Client: Town of Addison Date: 1/2/18  
 Program: ADA Self-Evaluation and Transition Plan Prepared By: CMP  
 KHA No.: 063543021 Checked By: EPE

Corridor: Les Lacs Ave GPS ID: 265  
 Project Name: Intersection of Les Lacs Ave and Waterford Dr  
 Town: Addison

Ramp 1A

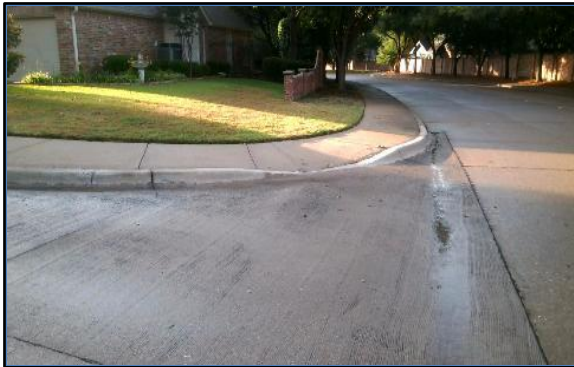
Curb Ramp Issues	Curb Ramp ID ('2' or '1' in ramp label indicates no existing ramp)				Possible Solutions
	1A	2A	3A	4A	
Curb ramp does not exist and is needed					
Curb ramp does not land in crosswalk					
No 4' x 4' clear space at base of curb ramp					
Curbed side is not 90° or has traversable adjacent surface					
Flare cross slope is greater than 10%	X		X	X	Remove and replace curb ramp
Curb ramp running slope is greater than 8.3%	X		X	X	
Blended transition running slope is greater than 5%					
Cut-thru ramp running slope is greater than 5%					
Curb ramp cross slope is greater than 2%				X	
Cut-thru ramp cross slope is greater than 2%					
Curb ramp width is less than 48"					
Cut-thru ramp width is less than 60"					
Permanent obstruction (>0.25") in curb ramp/landing/flares			X		
Temporary obstruction (>0.25") in curb ramp/landing/flares					
No textured surface at base of curb ramp	X	X	X	X	For intersection, commercial driveway, and park ramps, install color truncated domes

No color contrast at base of curb ramp	X	X	X	X	
Landing area does not exist and is needed	X	X	X	X	Install landing area
Landing area is less than 5' x 5' or slopes greater than 2%					
Curb ramp transition onto roadway is greater than 0.25'	X	X	X	X	Fix curb ramp transition
Counter slope of the gutter or street at the foot of the curb ramp is greater than 5%					
Ponding occurs at base of curb ramp
